**THE APPLICATION AND CONFORMITY  
OF THE  
JAPANESE NUCLEAR REGULATION AUTHORITY'S  
NEW SAFETY STANDARDS FOR NUCLEAR POWER PLANTS**

***THE ASSESSMENT GUIDE OF VOLCANIC EFFECTS TO THE NUCLEAR POWER PLANT***

***VOLCANIC HAZARDS IN SITE EVALUATION FOR NUCLEAR INSTALLATIONS SSG-21, 2012***

**Opinion and Statement of JOHN H LARGE**

**SCHEMATIC 1 IAEA APPROACH TO NPP SITE VOLCANIC HAZARD ASSESSMENT FOR DESIGN**

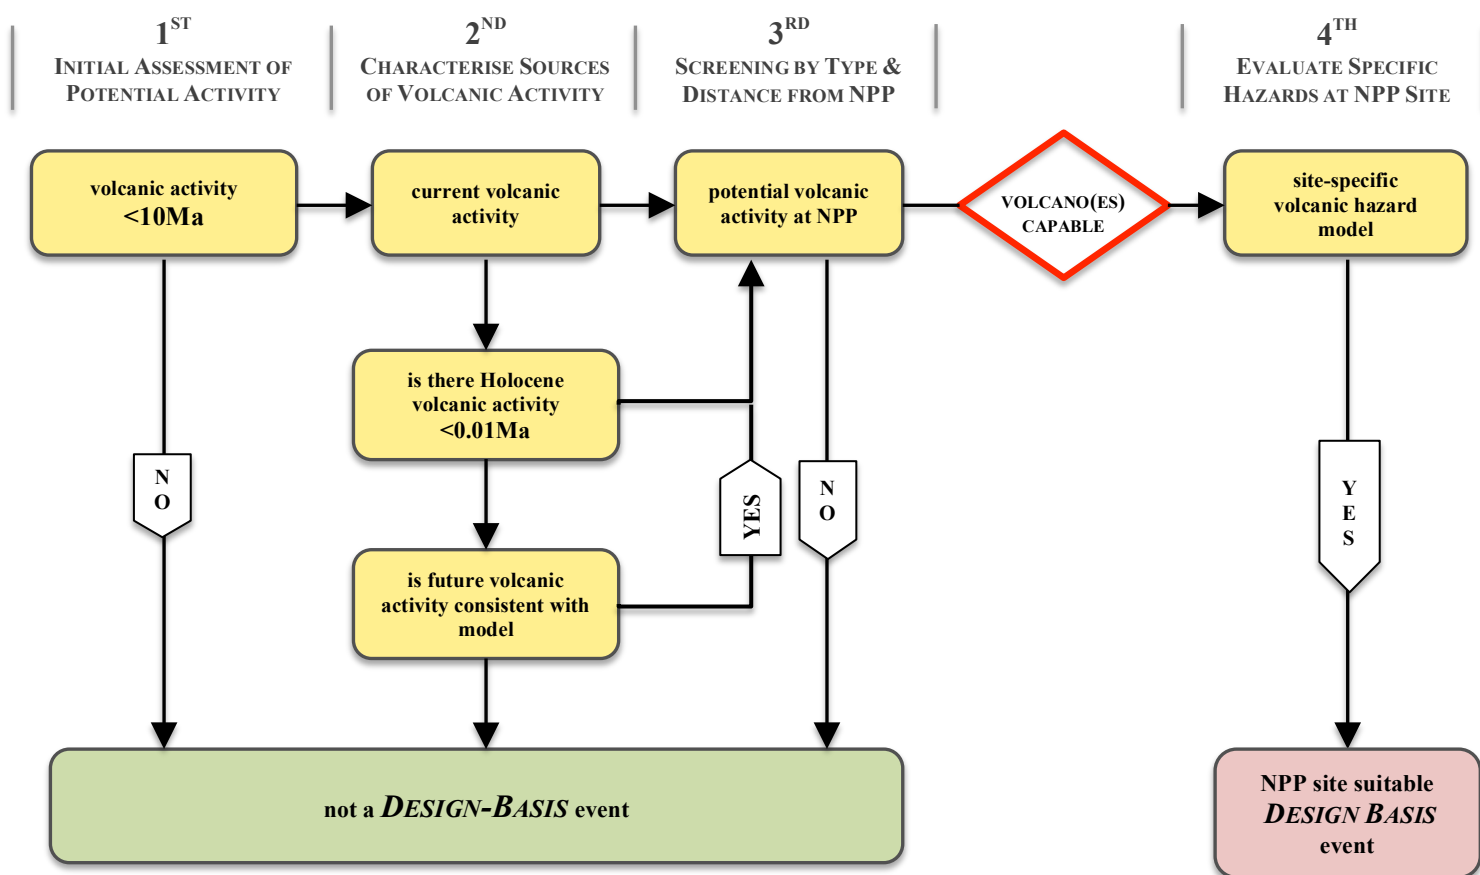
- 18 As shown by **SCHEMATIC 1** [after IAEA Figure 1, p16], the advocated site selection process is a sequential process, based upon and identifying the need for increasing levels of information relating to the increasing levels of potential hazard for at the NPP site.
- 19 The 1<sup>st</sup>, 2<sup>nd</sup> and 3<sup>rd</sup> levels or stages of screening evaluate the potential magnitude and frequency of occurrence of potentially active volcanoes and/or volcanic fields in the

53 Consider the English language version of Figure 1 of VAG, reproduced below, which purportedly mimics Figure 1 of IAEA SSG-21 (as reproduced in ¶17).

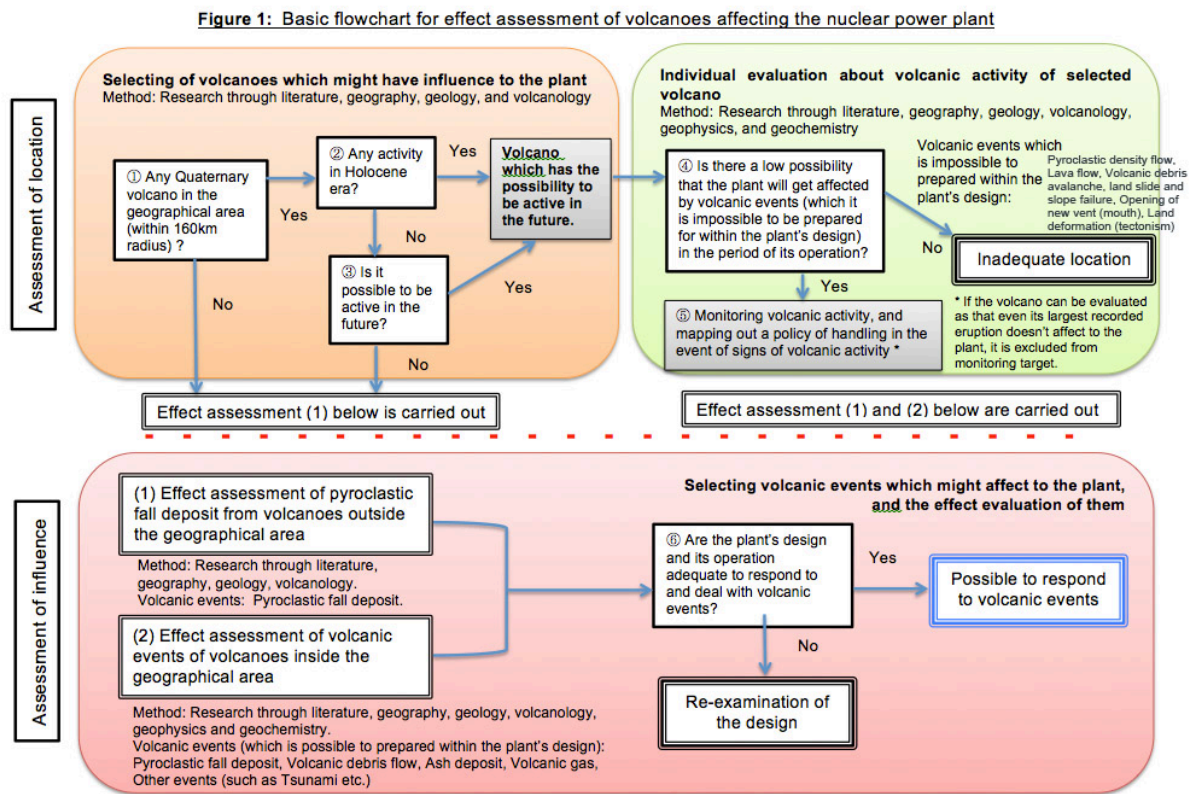
54 Under item 5 (in the right hand green box ■ above) the asterisked caveat states that “... If the volcano can be evaluated as that even its largest recorded eruption doesn't affect to the plant, it is excluded from the monitoring target’.

55 In effect, by excluding volcanoes on the basis of the magnitude of past events alone, this runs counter to the IAEA approach that evidence of an eruption during the Holocene (last 10,000 years) is a widely accepted and reliable indicator that future eruptions are

- 56 In fact, the IAEA recognizes that the geologic record, as wholly relied upon in item 5 VAG above, is usually incomplete and smaller past eruptive events may have not been preserved in the geologic record. The possible absence of some past events from the geologic record are sources of uncertainties, giving rise to aleatory variability<sup>3</sup> that needs to be properly addressed in the NPP site volcanic hazard assessment.
